Sharktooth Bluffs Basin Storm Drainage Master Plan September 2019

RE: Sharktooth Bluffs Basin Storm Drainage Master Plan

ICON Engineering, Inc. is pleased to submit the Final Conceptual Design Report for the Sharktooth Bluffs Storm Drainage Master Plan. This submittal includes revisions to the report based on comments received on the DRAFT Conceptual Design Report.

Sharktooth Bluffs Basin Masterplan								
Comment and Response Tracking								
Draft Baseline H+H Report								
No.	YOUR NAME (last name, first name)	SECTION #	PAGE	LINE	COMMENT	S, R, E (Substantive, Requested, Editorial)	A, R, C (Accepted, Rejected with explanation, Needs Clarification)	RESPONSE (by consultant)
27	Fisher, Andrew	Study Area Map	7	Figure 2.1	Please add Long Range Growth boundary to map as well, if it can be depicted clearly. This may require a Study Area Map for present day boundaries and a separate map for future forecasted boundaries.	R		A vicinity map was added to show the LRG boundary in relationship to the Sharktooth Bluffs Boundary
28	Fisher, Andrew	Subwatershed Map	8	Figure 2.2	Please increase the size of Tributary labels to the size of the Jones Ditch and No.3 canal at minimum	R		Size has be

Figure 2.2 - Study Area Map

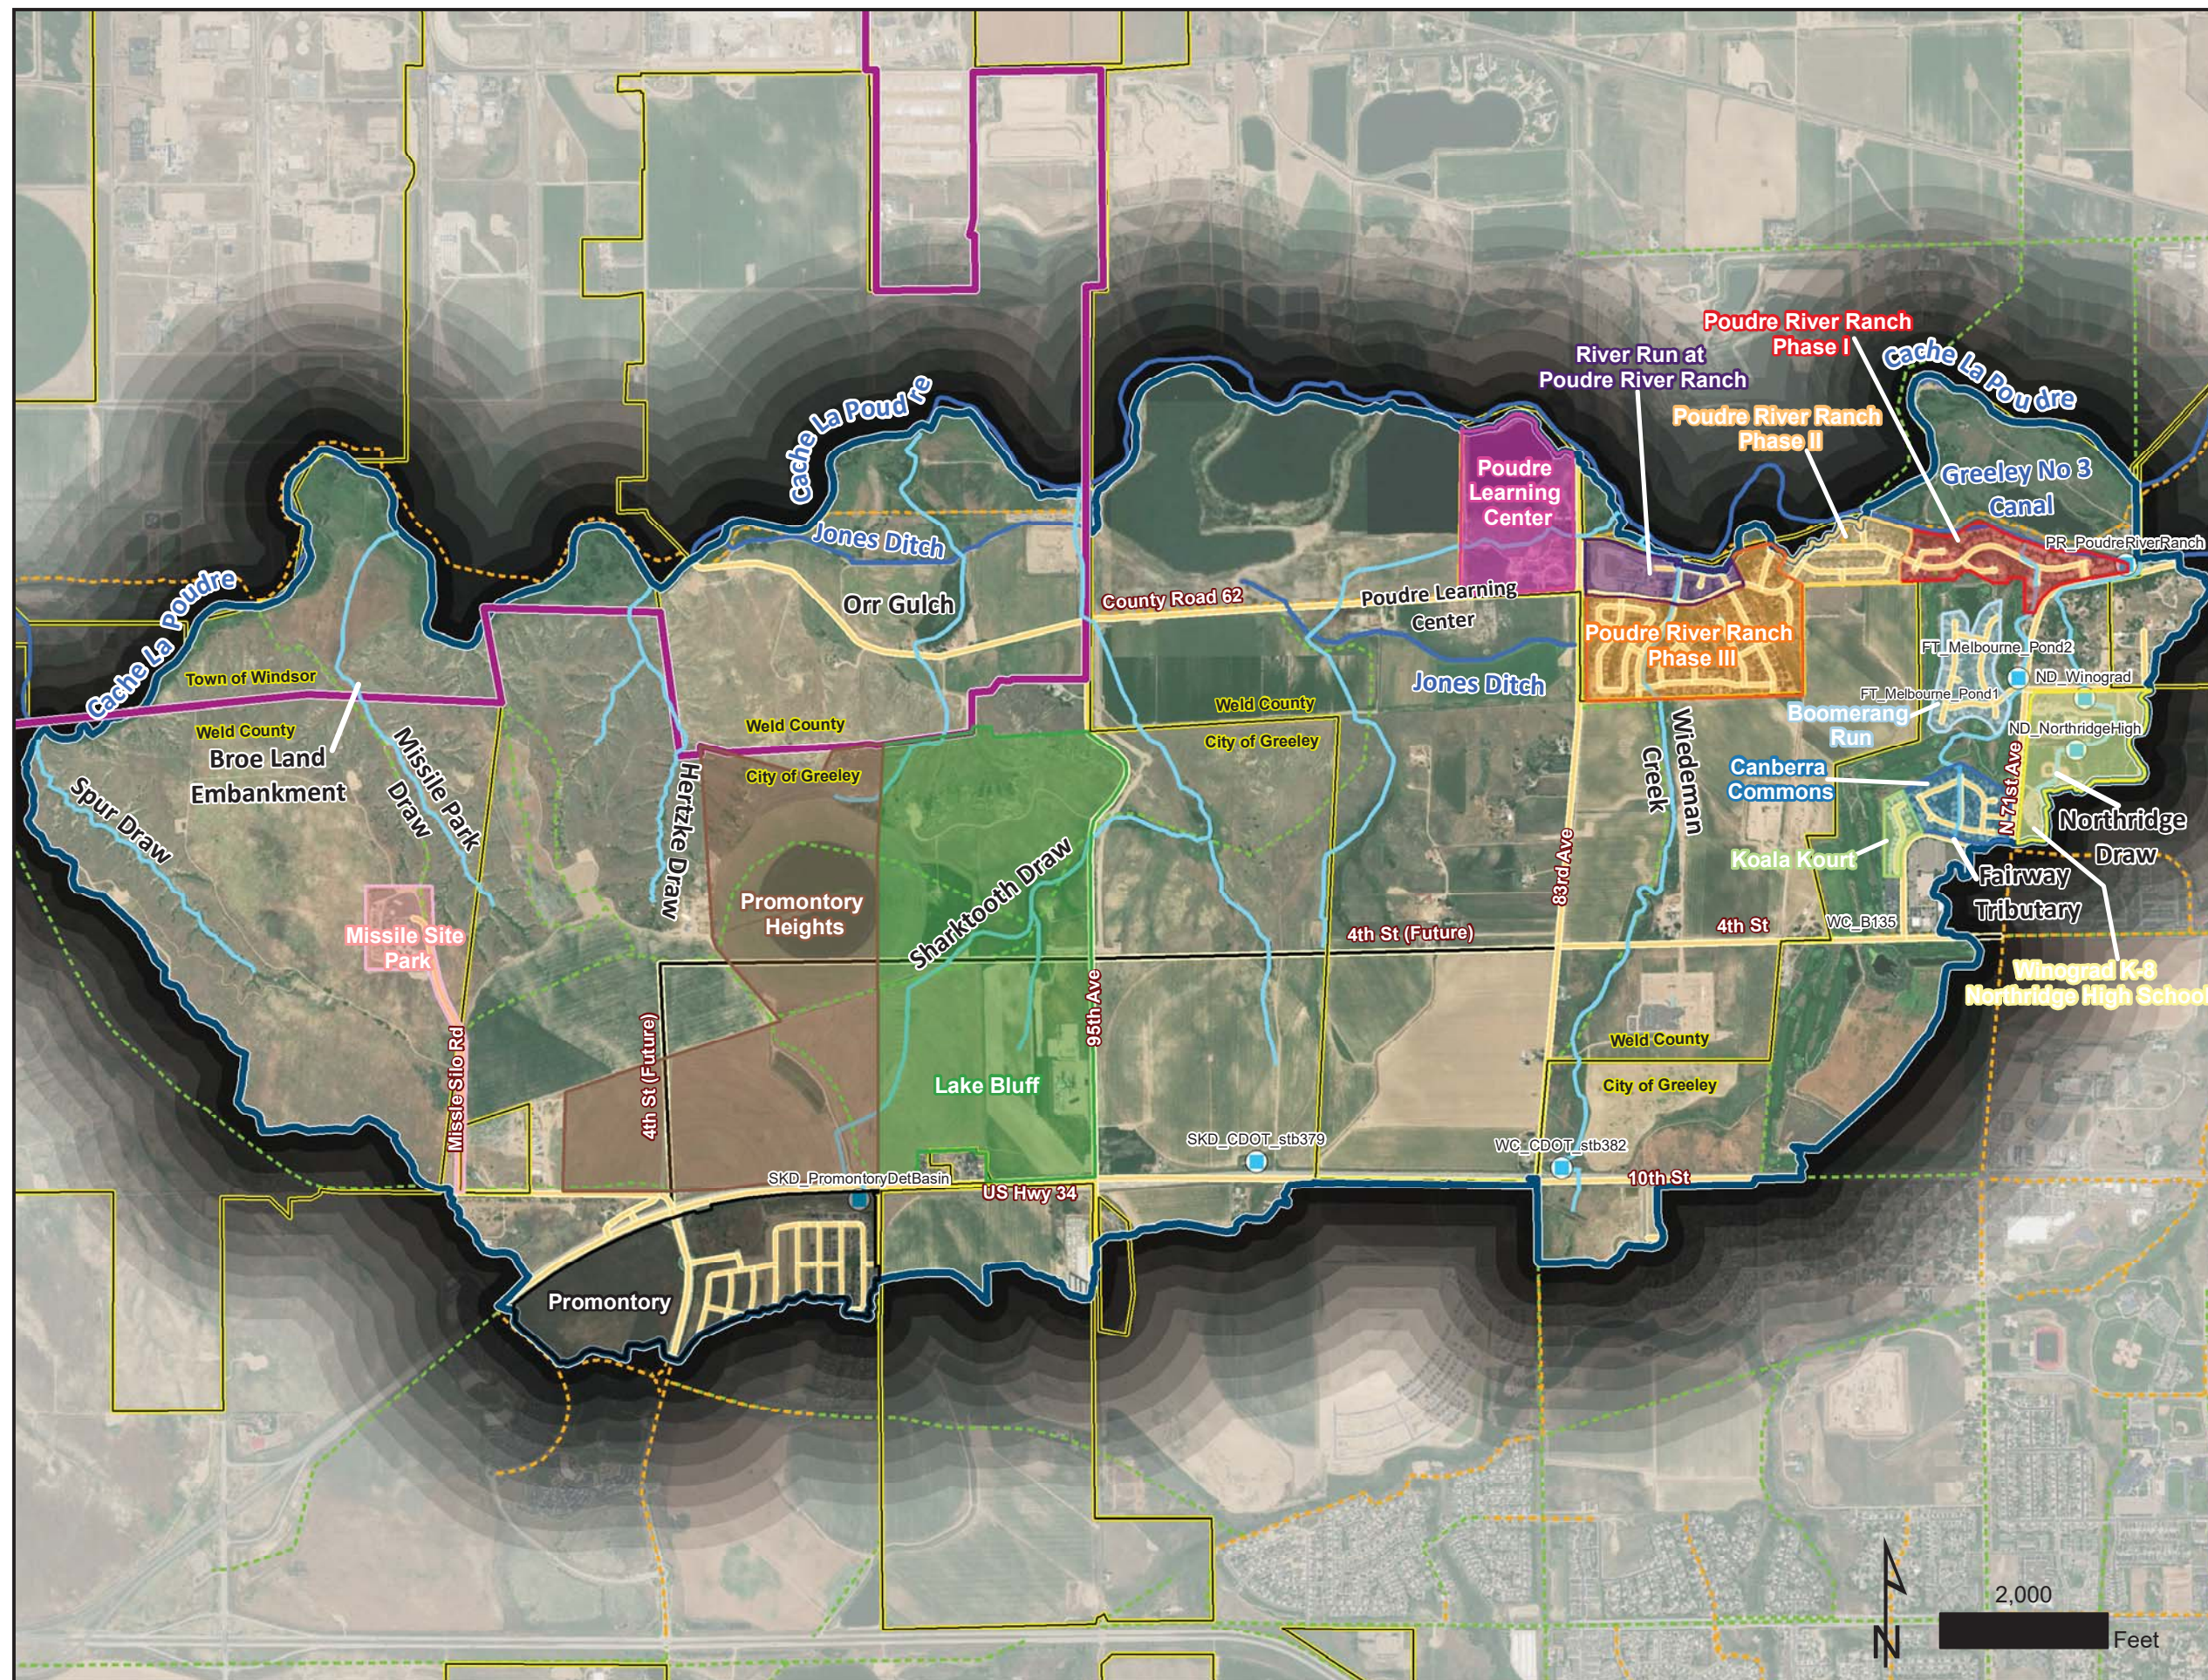
30	Fisher, Andrew	Subwatershed Map	8	Figure 2.2	Please either show the original boundary between West Poudre and Sheep Draw basins, or if the boundary is sufficiently close, add a note that Wiedeman Creek, Fairway Tributary, Northridge Draw, Poudre River Ranch and the direct flow area north of Greeley No 3 Canal were previously considered part of the Sheep Draw Basin in the 2006 Anderson report	R		Boundary is now shown
31	Fisher, Andrew	3.2	9	6	Please spell out UDFCD acronym at first mention	E	A	Comment addressed
32	Fisher, Andrew	3.4.1	9	2	Revise spelling of Missile, Hertzke and Orr	E	A	Comment addressed
33	Fisher, Andrew	3.4.2.2	10	2	Please revise to state Imagine Greeley Land Use Guidance Map, adopted in January 2018.	R	A	Comment addressed
34	Fisher, Andrew	3.4.3	10	2	Please clarify source of topographic data	R	A	Comment addressed
35	Fisher, Andrew	3.4.5	10	Paragraph 3	In this paragraph, please clarify that this procedure was completed on Type A and B soils in areas found to be actively irrigated agricultural land, as identified by inspection or historic aerial photographs.		A	Paragraph was revised to clarify
